ADDENDUM

ADDENDUM NO.: 03
PROJECT NAME: WPA Street Reconstruction (E 109th St., S Hoyne Ave., S Harding Ave., E 102nd St.)
PROJECT NO.: 22312, 22313, 22314, and 22329
CONTRACT NO.: C1616
DATE OF ISSUE: December 2, 2024

NOTICE OF CHANGES, MODIFICATIONS, OR CLARIFICATIONS TO CONTRACT DOCUMENTS

SCALE: 1"=20'	SHEET 2	OF 2 SHEETS	STA. TO STA.	F.A. RTE.	SECTION	COUNTY	TOTAL SHEETS	SHEET NO.	
							COOK	31	3
							CONTRACT NO. C1616		
							ILLINOIS	FED. AID PROJECT

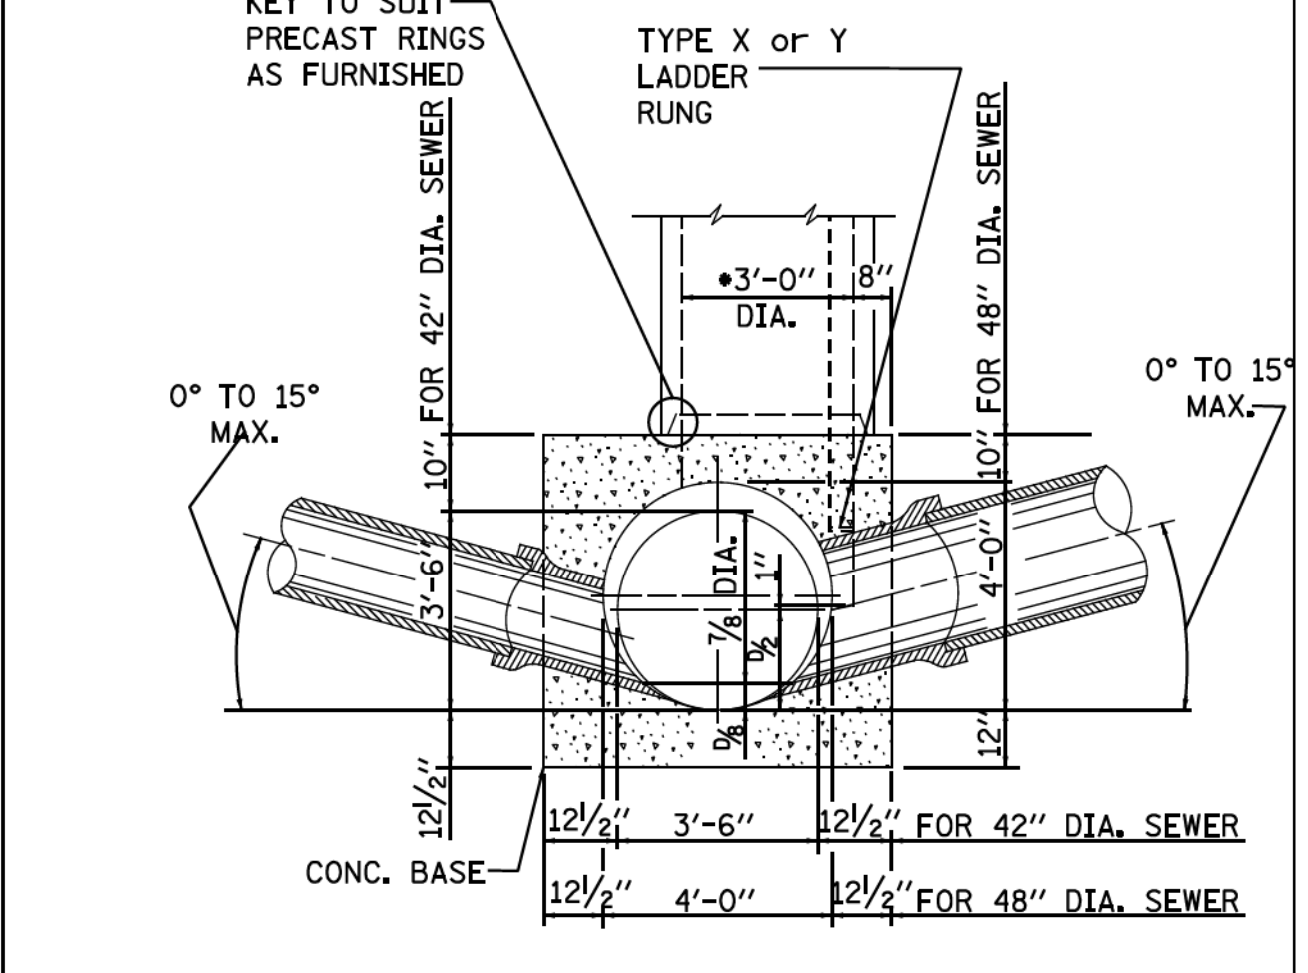
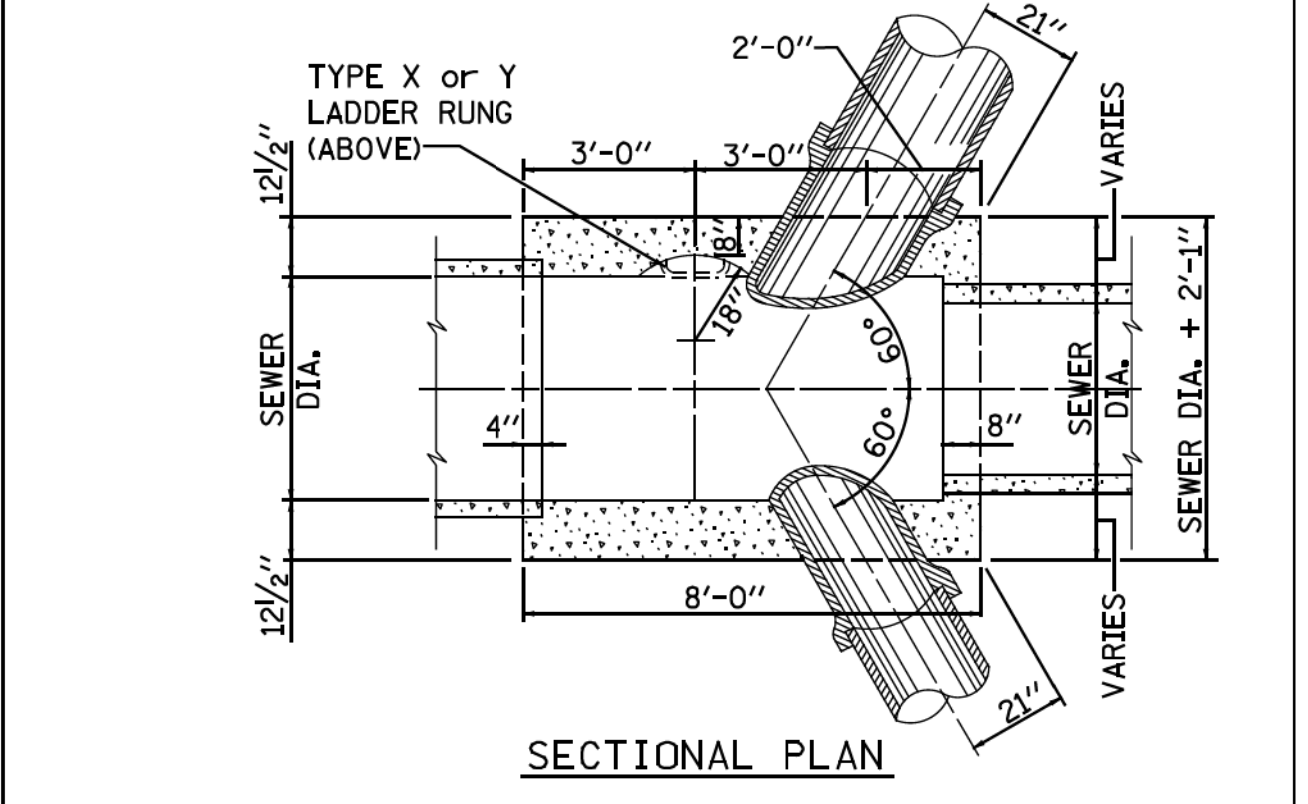
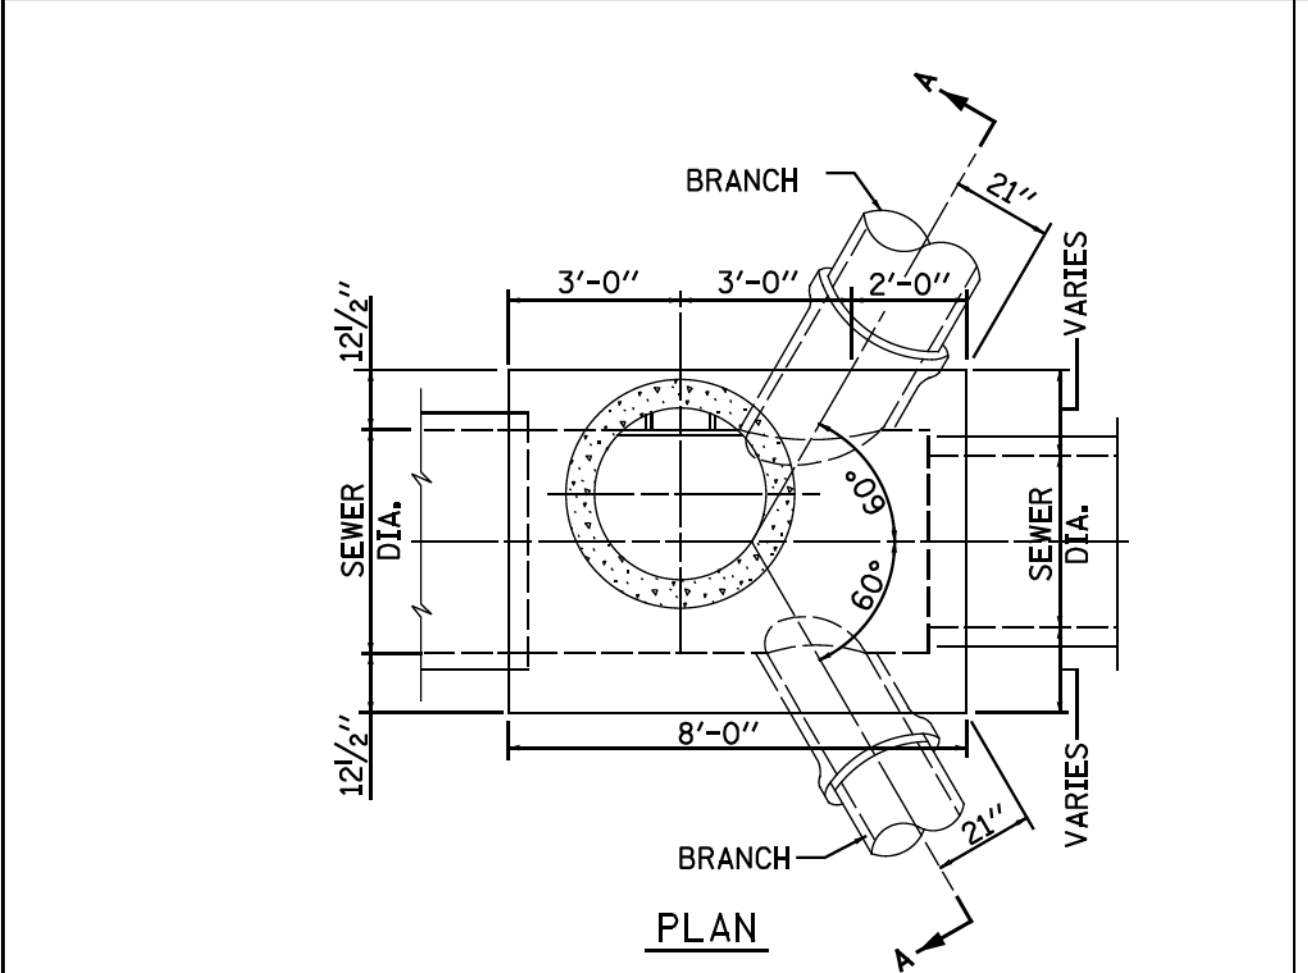
Change 1 **DELETE** SHEET 3 for E. 109th; S. Hoyne; S. Harding; and E. 102nd; and **REPLACE** with Revised SHEET 3 for E. 109th; S. Hoyne; S. Harding; and E. 102nd; included in this Addendum No. 3. – *Unit quantities updated as indicated on each sheet.*
